51-0058-M
Page 2 of 3

Modification No. P-00012
Date: 3 Dec 92
Contract No. DAKS-91-C-0051
Dated: 29 Aug 91

PROJECT: ROANOKE SEWAGE TREATMENT PLANT
CLIENT: JONES GRADING & FENCING, INC.
DESIGNED BY: RICHARD L. WILLIAMS, P.E.
CONSULTING ENGINEERS, INC.
4818 COLONIAL AVENUE
ROANOKE, VIRGINIA 24018
PHONE (703) 774-5708
COMB. NO. 10/27/92
SHEET NO. 2

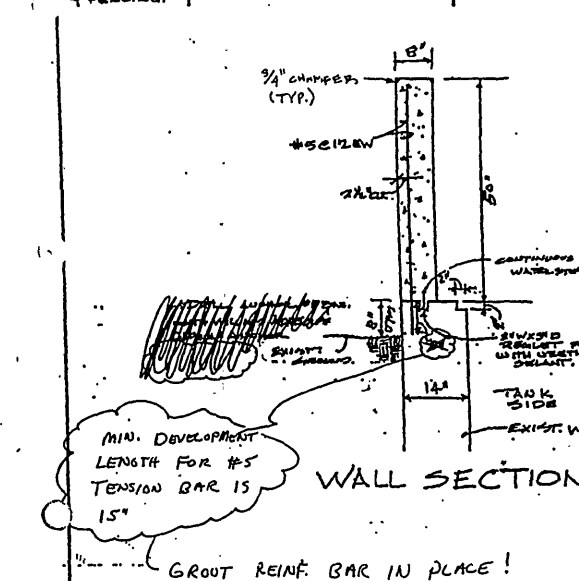
b. CONTRACT DRAWING CHANGES: By pen and ink, on plates M-1 and M-2, delete all references to the originally designed mixer shaft extension and replace with the details shown on the two attached Government modified contractor prepared sketches. Also add the following notes:

1. The existing electrical panels shall be mounted to the new concrete wall at the same elevation as existing. Relocate electrical conduit to a location under the existing grating. Raise existing chemical flow tube and existing electrical conduit to accommodate installation of PVC waterstop.

2. Cut existing handrail and place onto the concrete wall by means of a stanchion.
3. The vertical reinforcing steel shall be grouted into the existing 1-foot, 2-inch wall. The correspondence embedment length for the vertical reinforcing steel shall be a minimum of 15 feet.

4. Expansion joints shall be provided in the sidewalk when abutting existing concrete surfaces and tooled construction joints shall be provided every 4 feet.

5. Chamfer all exposed edges of the new concrete wall.
6. The floodgate shall conform to the requirements of shop drawing P-MK-768-22, dated 10-16-92 (Transmittal 05500-23).

7. Grade sidewalk and surrounding area to drain.
